**RE: Reply to Notice in accordance with Article 14(2)(b)(ii) of the Waste Management (Licensing) Regulations for Application 221-1**

On behalf of our client, Dublin City Council, and with reference to your letter dated the 3<sup>rd</sup> of October 2005, in relation to Article 14(2)(b)(ii) request for information pertaining to the Waste Licence Application by Dublin City Council to develop a Civic Amenity Site at a site in Labre Park, Ballyfermot, Dublin 20 (221-1), please find below the information as requested.

**Responses to request for further information on  
Environmental Impact Statement (EIS) for  
proposed Civic Amenity Facility at Labre Park,  
Ballyfermot, Dublin 10**

## Appendix 2: Drawing 24014-015

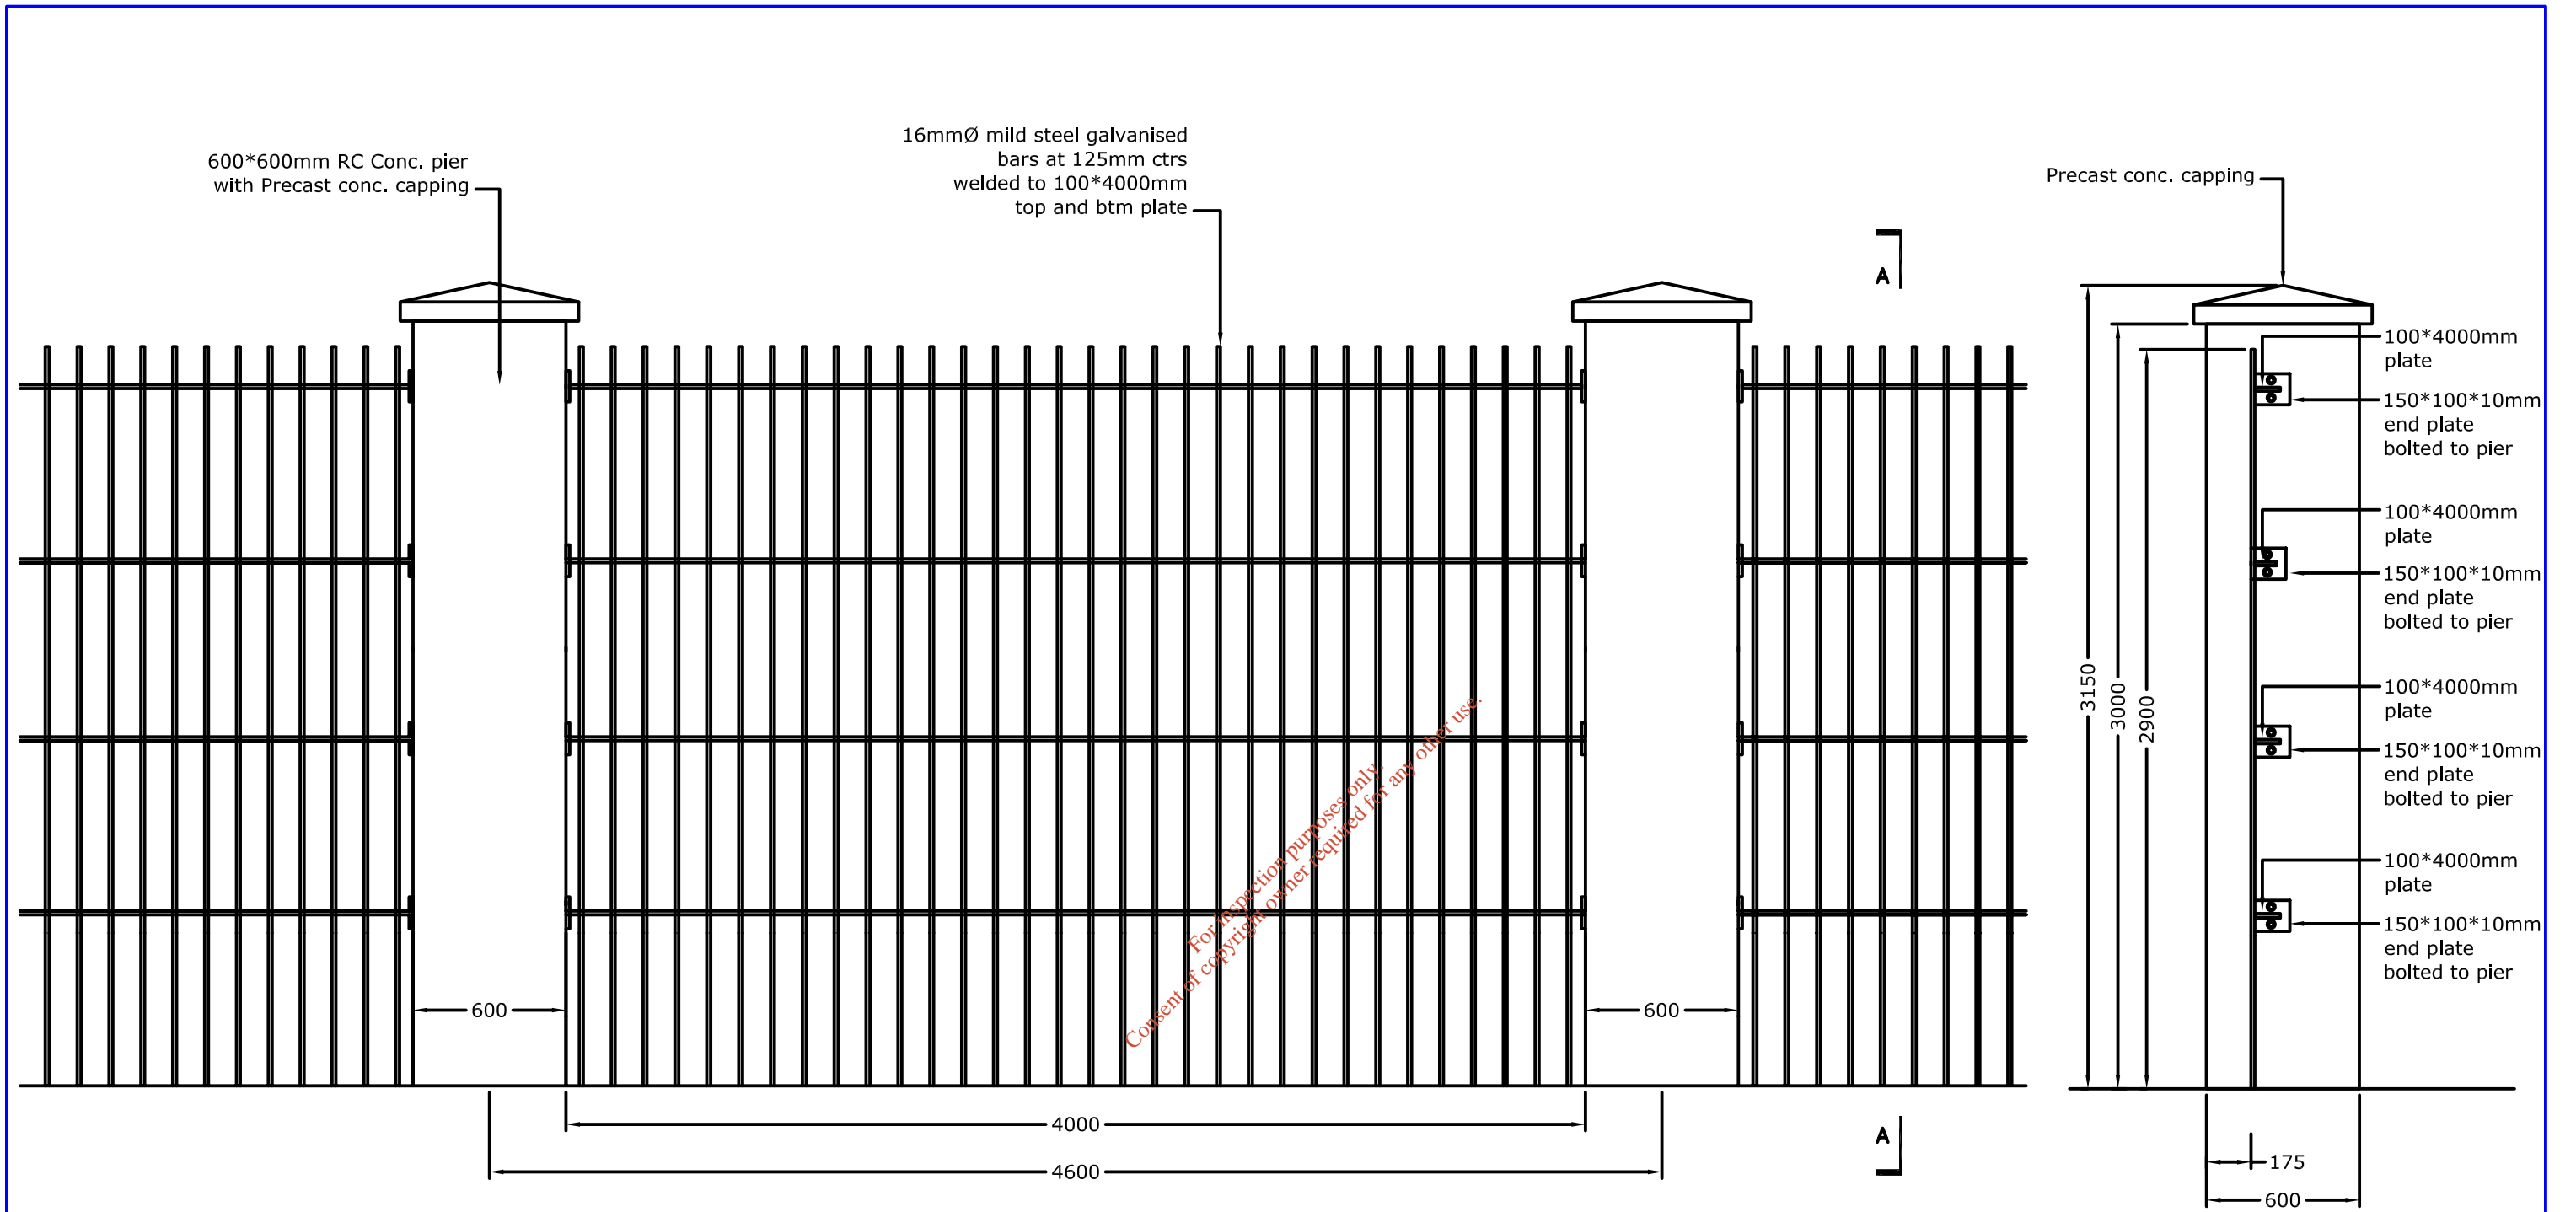
1. Drawings indicating the following:
  - (a) Indicative boundary wall construction, including details of height, use(if any) of railings, proposed surface treatment.

Drawing 24014-015 (Appendix 2) details the boundary fence proposed along the remaining site boundaries. This design has no wall at the base of the fencing to allow for the free flow of water through the site in the event of severe flooding. On the northern boundary of the site access will be provided to the bank of the Galback Stream via gates at the locations indicated on Drawings 24014-003B.

DRAWING TITLE **PROPOSED DRAINAGE PLAN**

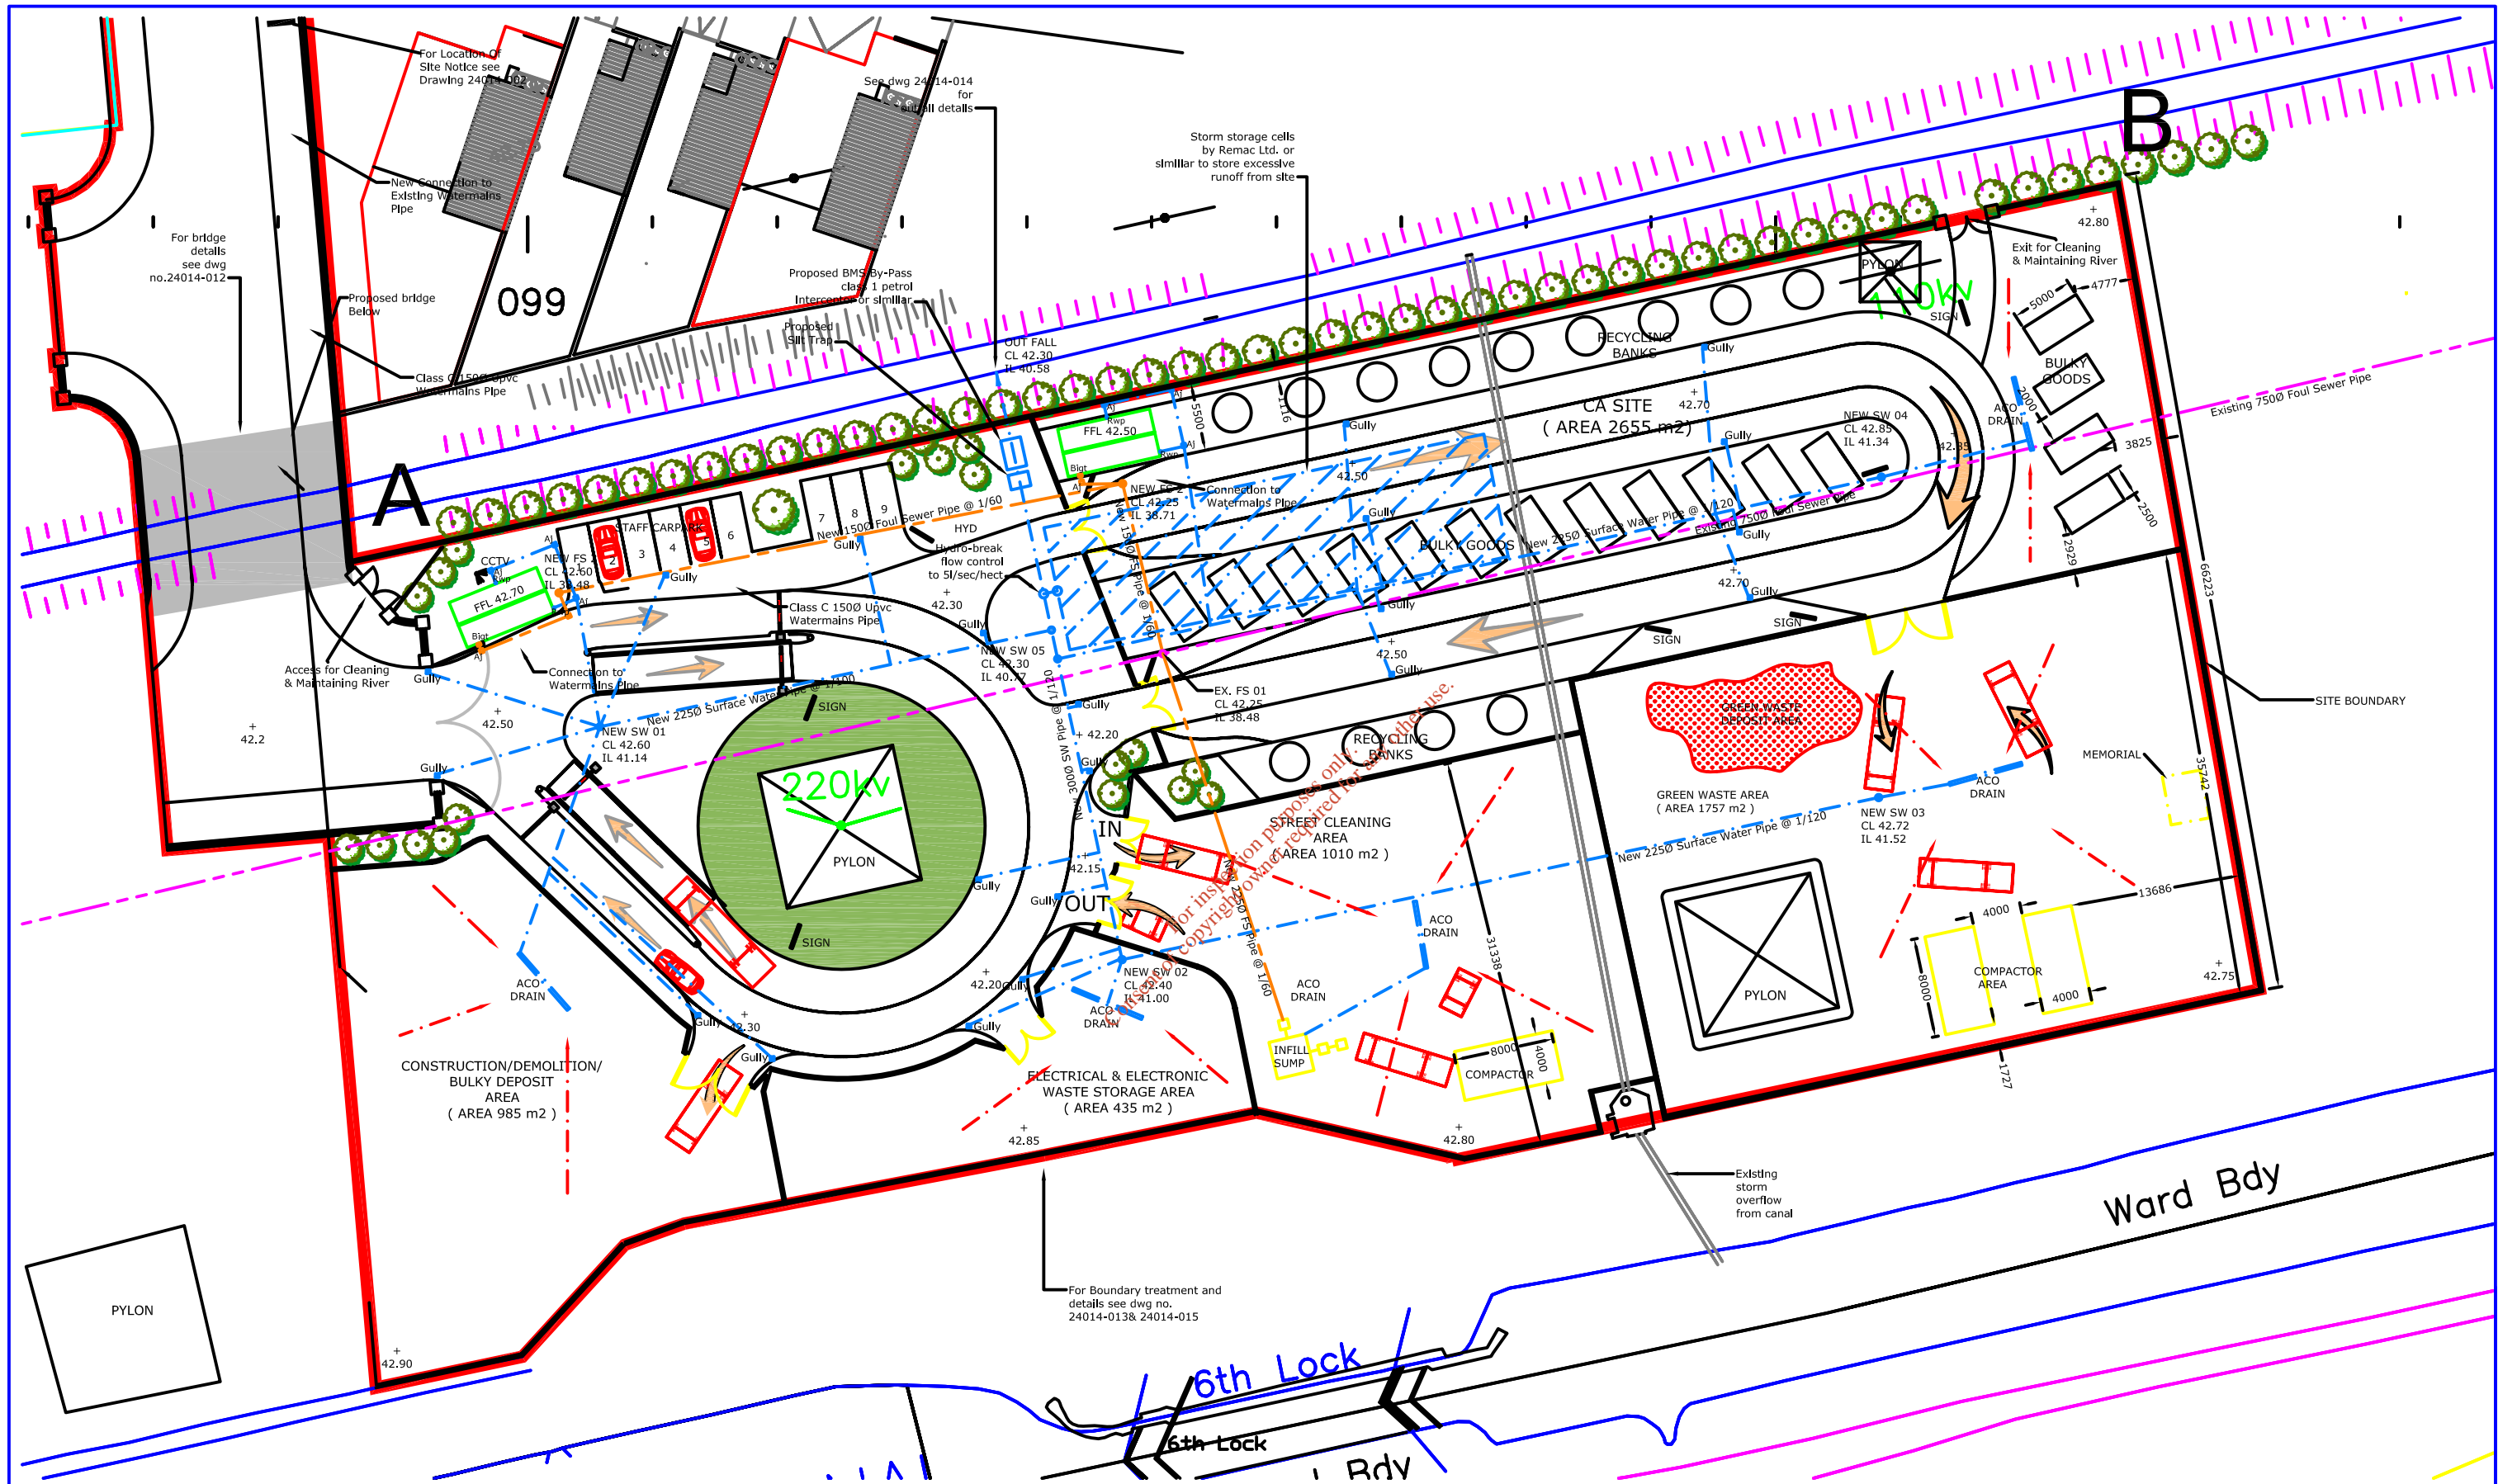
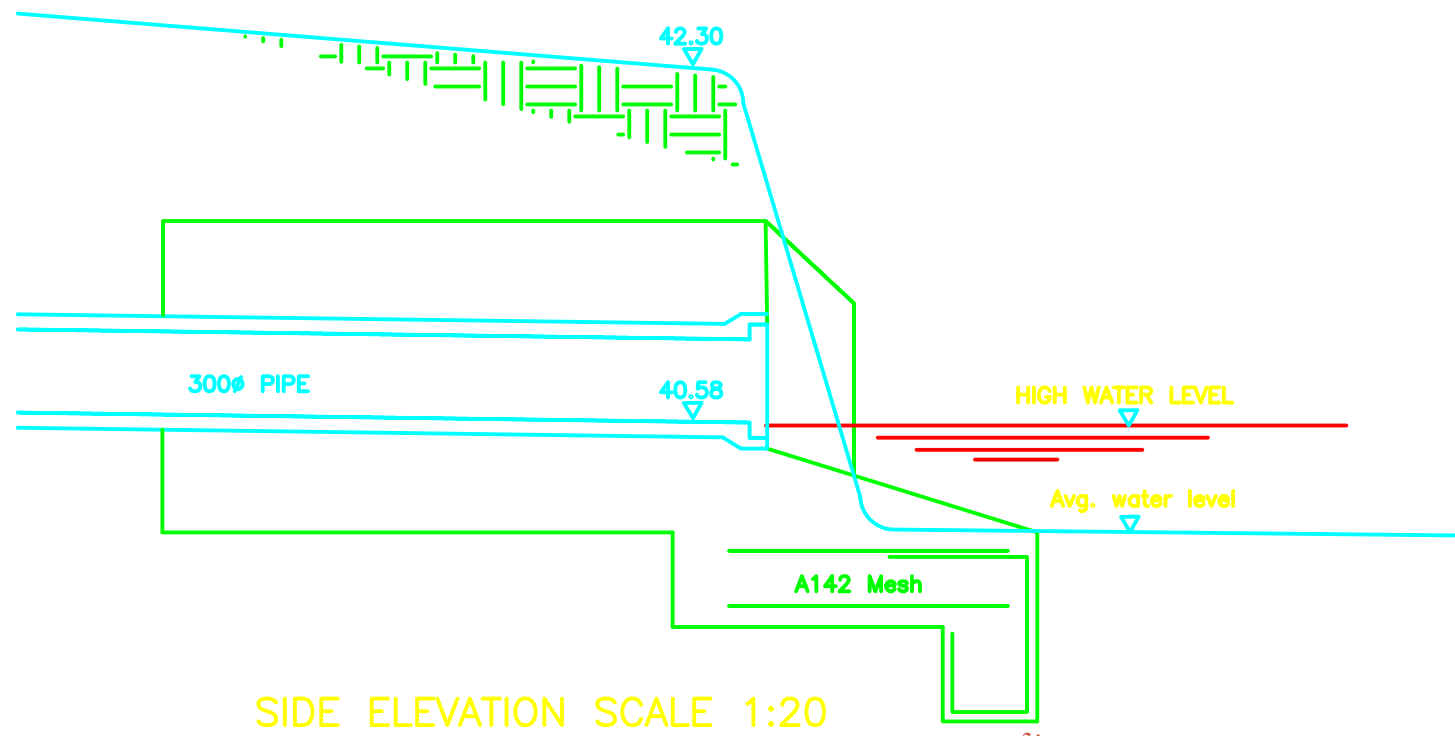
- (b) Hydrocarbon interceptors, referred to in text, but not included in Drainage Drawings.
  - (c) Surface water attenuation tanks, referred to in text but not in Drainage Drawings.

Drawing 24014-003B (Appendix 3) has been amended to include the hydrocarbon interceptor referred to in the text of the EIS.

The interceptor used will be manufactured from a robust material such as glass reinforced polystyrene and will be rot-proof. The capacity of the interceptor is 6,600 litres and is suitable for this development, as the site has been classed as low risk - there will be no fuel delivery tanks or fuel storage tanks on the site. The site will be a low risk area where there is a risk of frequent oil contamination of surface water runoff, but in low concentrations and small quantities.

Drawing 24014-003B (Appendix 3) has been amended to include a storm water attenuation tank referred to in the text of the EIS.

The surface water runoff from the site will be attenuated in an underground tank on the site. The tank will be sized to store 264 m<sup>3</sup> runoff, which is the runoff volume calculated for the site from a 1 in 30 year event.

## Appendix 4: Drawing 24014-014

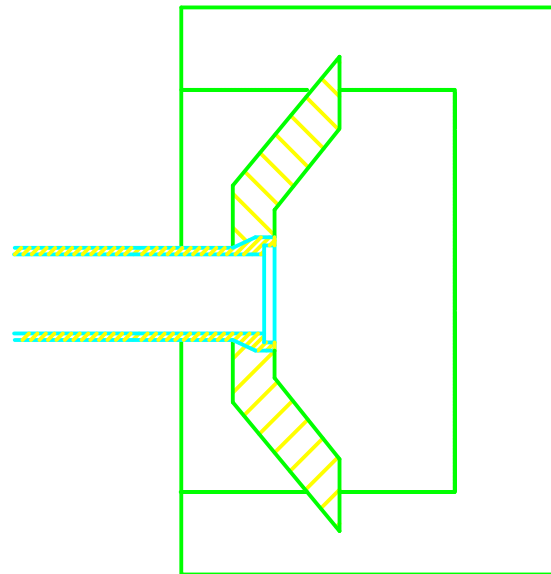
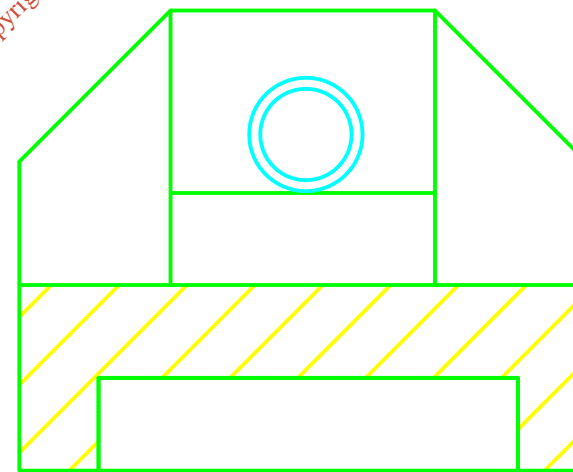
- (d) Drainage details of surface water outfall.
  - (e) Details of entrance with respect to proposed bridge indicated on drawing as being below the entrance.

Drawing 24014-014 (Appendix 4) details the proposed headwall for the surface water outfall to the adjacent stream.
